MONTGOMERY COUNTY HISTORIC PRESERVATION COMMISSION
STAFF REPORT

Address:	46 Philadelphia Ave., Takoma Park	Meeting Date:	10/12/2022
Resource:	Contributing Resource Takoma Park Historic District	Report Date:	10/05/2022
Applicant:	David Bates & Anne Leveque (Nelson Aquilar, Architect)	Public Notice:	09/28/2022
Review:	HAWP	Tax Credit:	n/a
Permit No.:	1006685	Staff:	Rebecca Ballo
Proposal:	Partial demolition and construction of new rear addition.

DAVID BATES & ANNE LEVEQUE DEMO REBUILD SUNROOM

3 EXISTING REAR ELEVATION
D-1 SCALE: 1/4"=1'-0"

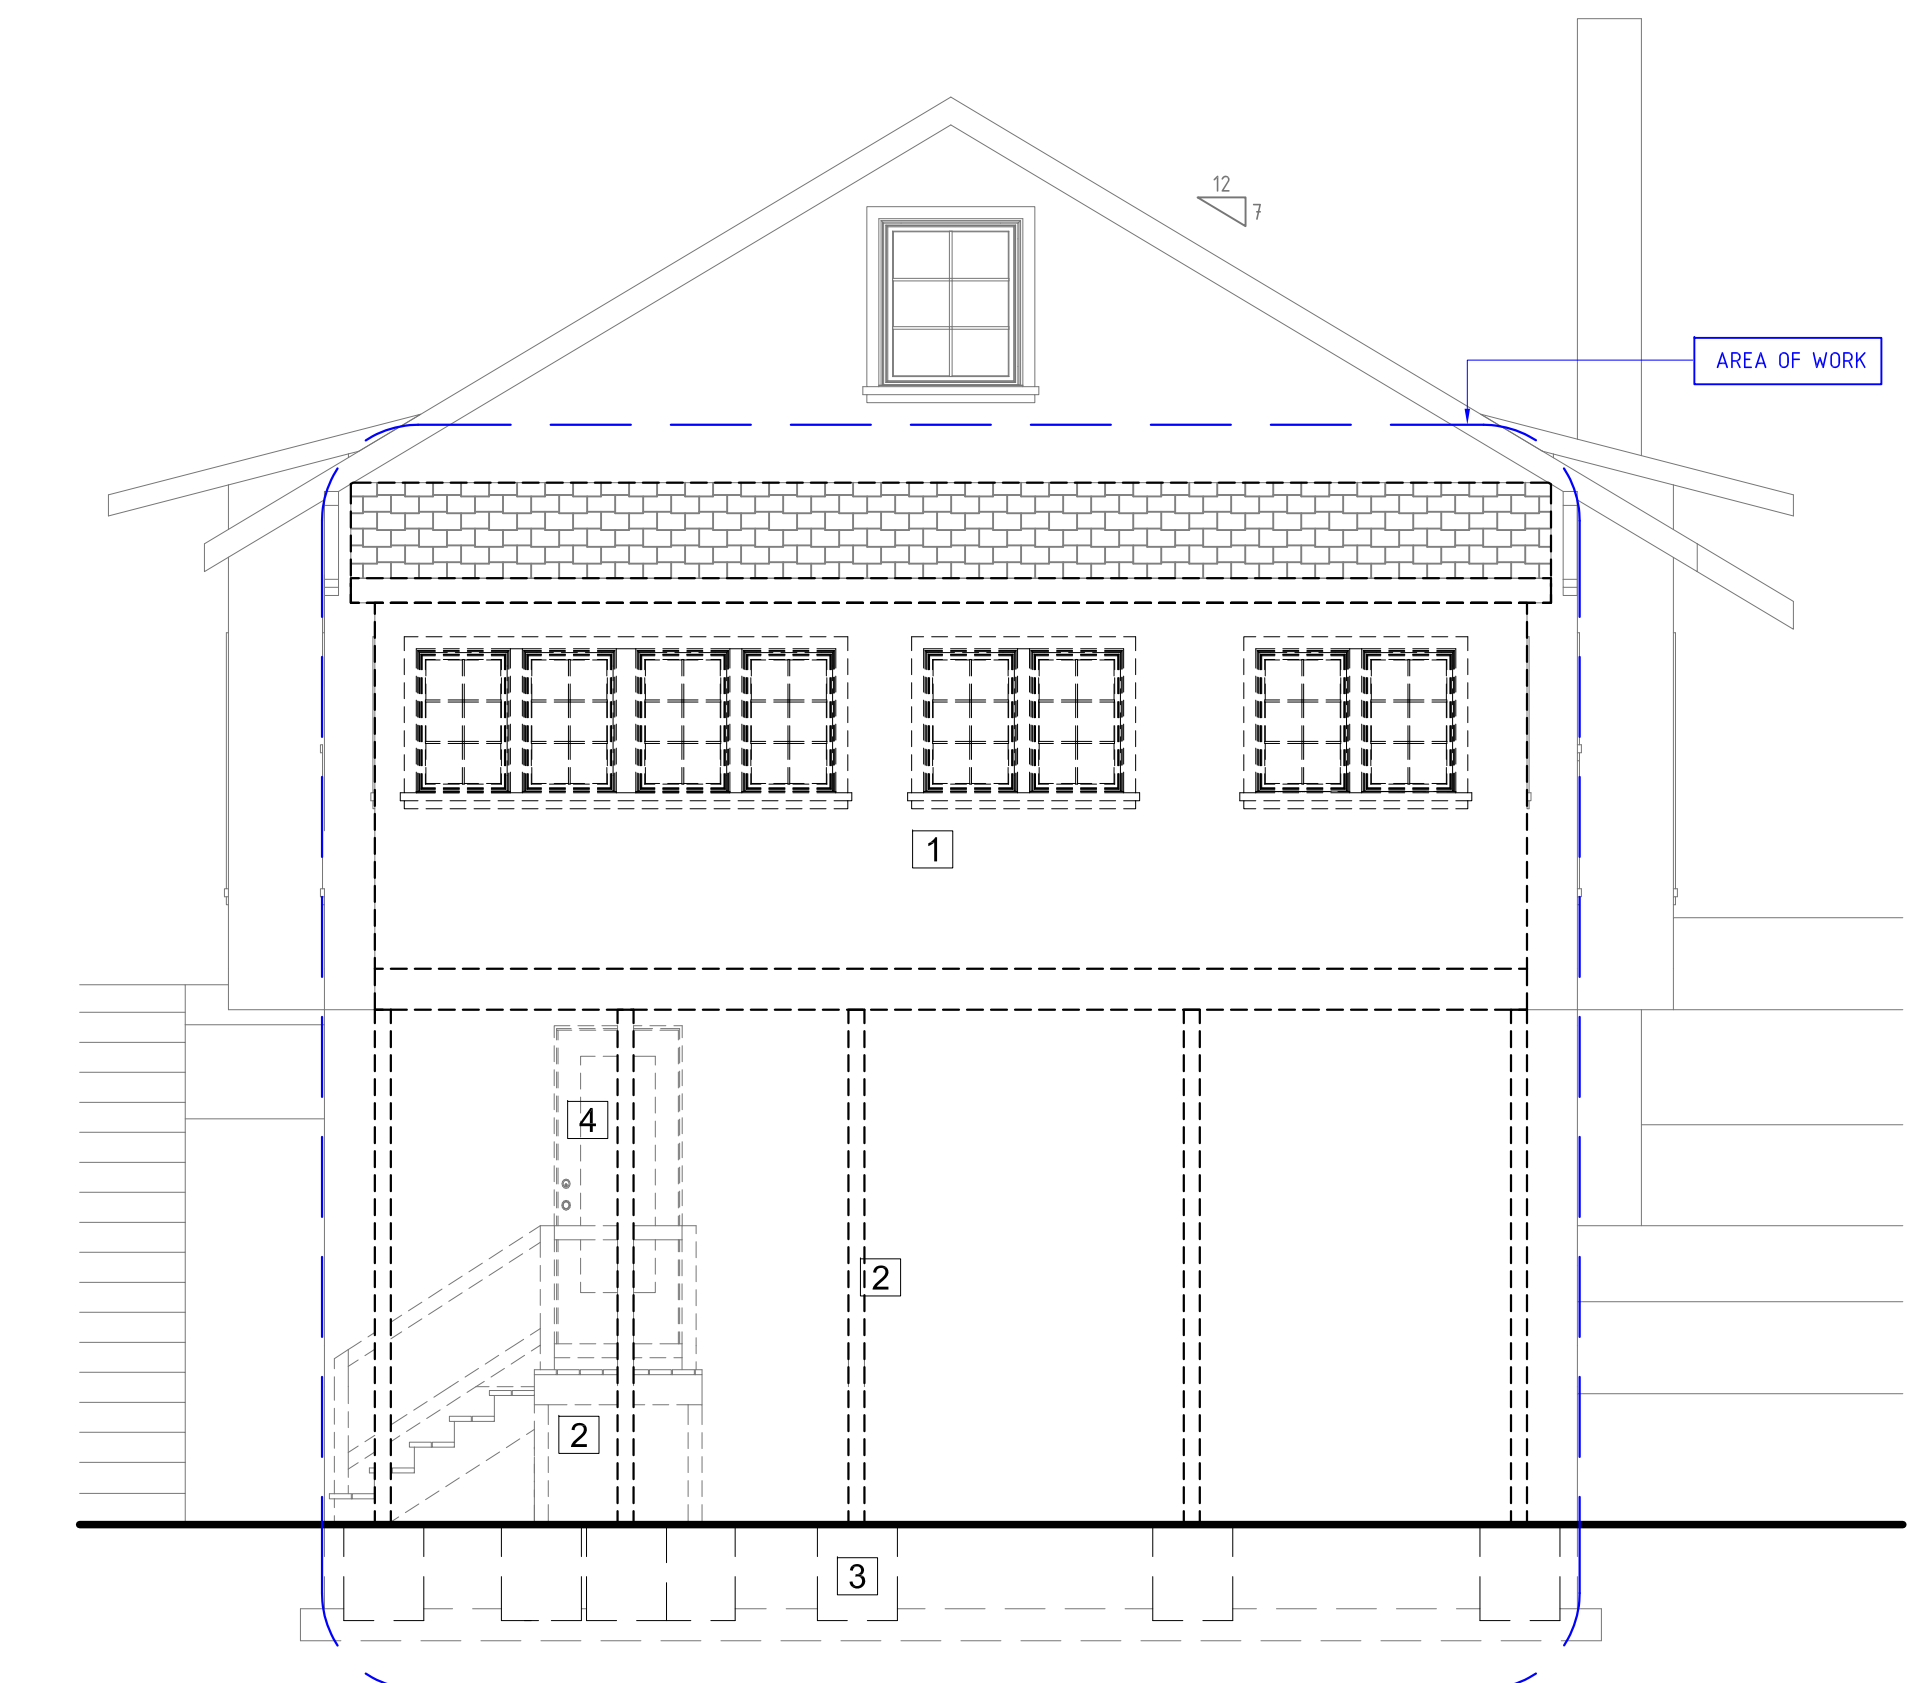
Staff finds that the existing sunroom is not historic and its demolition should be approved as a matter of course. Additionally, the new rear addition is compatible in size with this diminutive historic house. It takes advantages of the slope in the rear to create additional living space without compromising the original ridgeline of the historic house, preserves the existing brackets on the rear, and creates a design that is simple, compatible, and not overwhelming in size or style. The final window and door details can be reviewed by staff prior to final approval to ensure compatibility of muntin details and confirm the choice of materials.

1
A-4
PROPOSED REAR ELEVATION
SCALE: 1/4" = 1'-00"

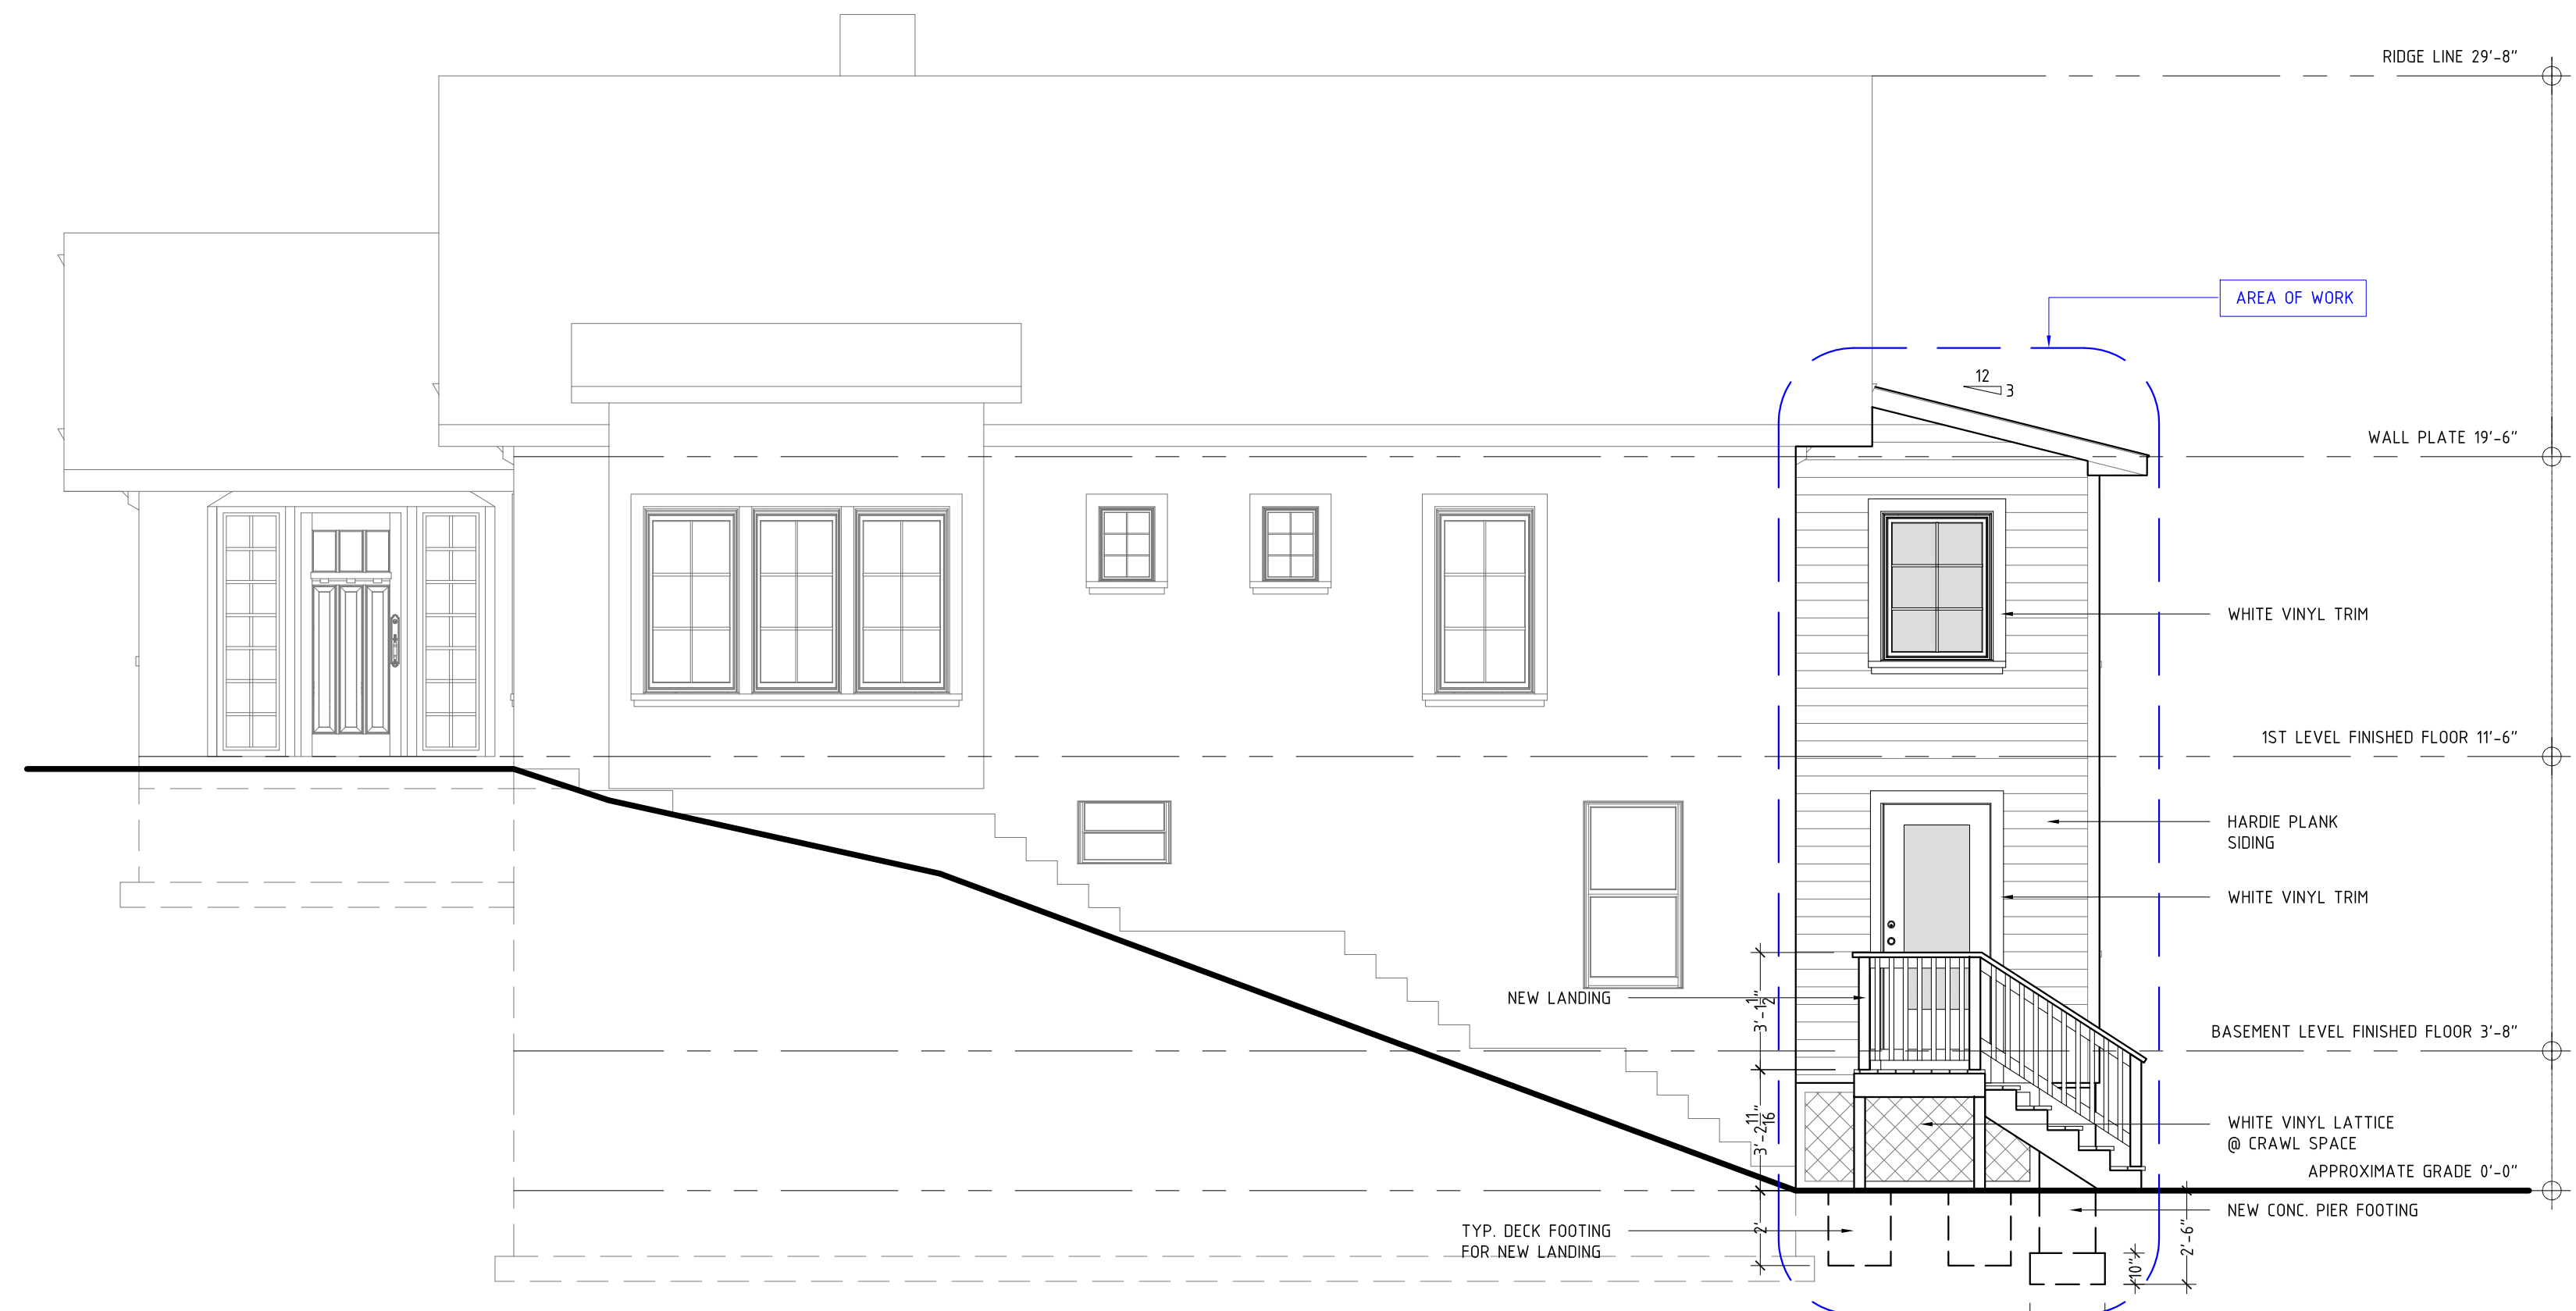
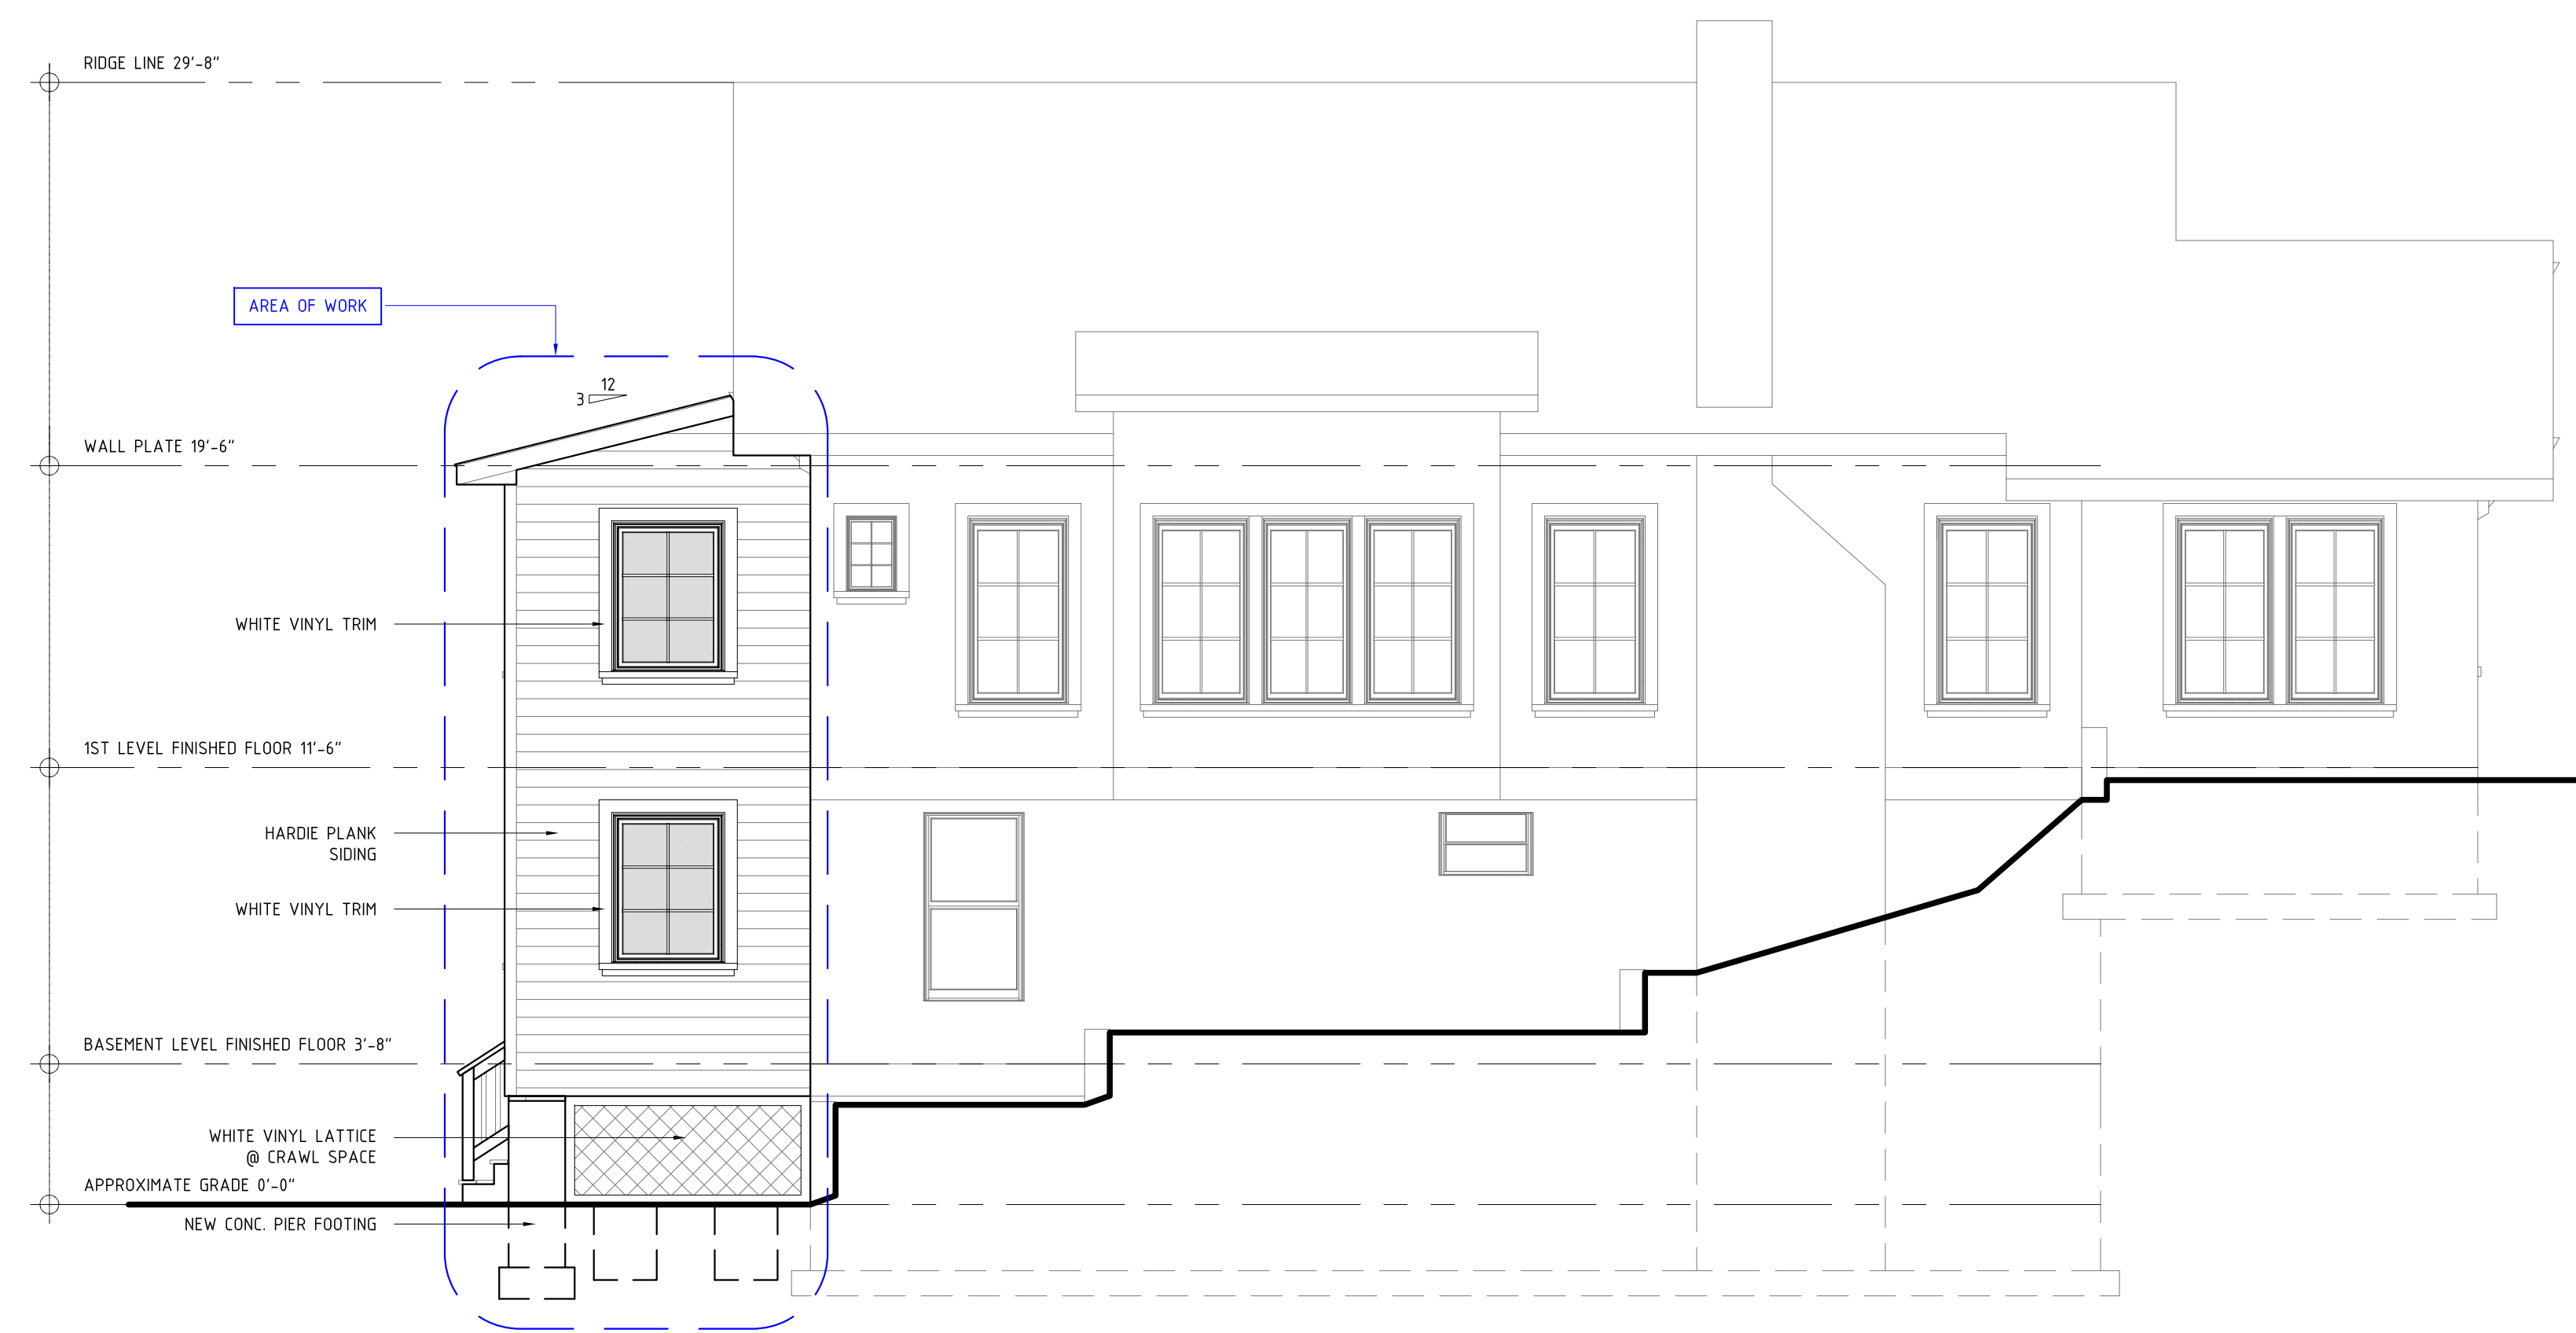
The window and door specifications were not included in the packet, but the trim is called out as vinyl. Staff recommends a condition to review the final window and door specifications to ensure the windows will have exterior applied muntins of a 5/8" minimum profile. The new addition will be supported by four newly poured concrete footings. The applicant is proposing to install white vinyl lattice between the footings to enclose the crawlspace as well as the space under the new landing. Typically vinyl lattice is not an approved material; however, this area will not be visible at all and the *Design Guidelines* provide for alterations such as this to be approved as a matter of course. A new wood landing and stairs are proposed to access the new door on the southern basement elevation.

- 1) All proposed new windows will be wood or aluminum-clad wood windows, with permanently-affixed interior and exterior muntins and internal spacer bars. Final review and approval of window and door specifications are delegated to staff.**
